Exhibit 13

From: Tan Minghua [charles_tan@126.com]
Sent: 8/7/2019 3:06:59 PM
To: jdearth [JDeearth@WhitestoneCC.com]
CC: ex02@yuandacn.com; pcarvelas [pcarvelas@WhitestoneCC.com]; sgrzic [SGrzic@WhitestoneCC.com]
Subject: Re:Re: RE: CUNY - Building movement @ WT-3 IMPORTANT
Attachments: Check D331G_SS.pdf

PROJECT: *City Tech Academic Building*

**STRUCTURAL CALCULATIONS
FOR
Bracket D331G
(REV.00)**

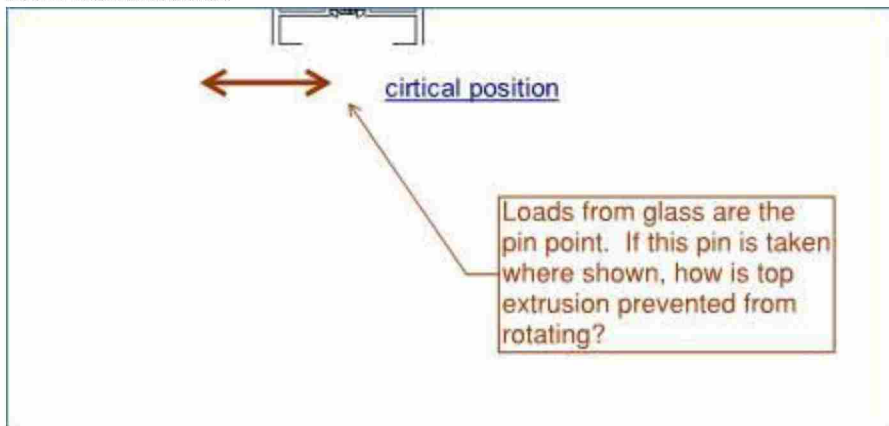
James,
Regarding RFI1636R6,
2. THE CALCS HAVE AN ERROR WHERE THE LOAD IS IMPOSED.
[YD: Refer to updated calculations and detailed drawings for more detailed information.](#)
[Note: the material of the aluminum angle circled in cloud line is 6063-T6, the thickness is changed from 1/4" to 5/16", and the quantity of connection screws and quantity of reinforcement bars are all changed. Of course, it would be even better if the aluminum angle can be changed to steel angle.](#)

3. CLARIFY HOW THE REINFORCING PLATES IN THE HEAD EXTRUSION WILL BE INSTALLED AT THIS POINT WHEN ALL THE FINISHES ARE ALREADY INSTALLED. THERE IS NO ACCESS AS EVERYTHING IS INSTALLED AND THERE ARE NO EXPOSED ENDS OF THE TUBES.
-THIS MUST BE EXPLAINED.
[YD: That back pan cannot be re-installed unless the extrusion is dismantled.](#)
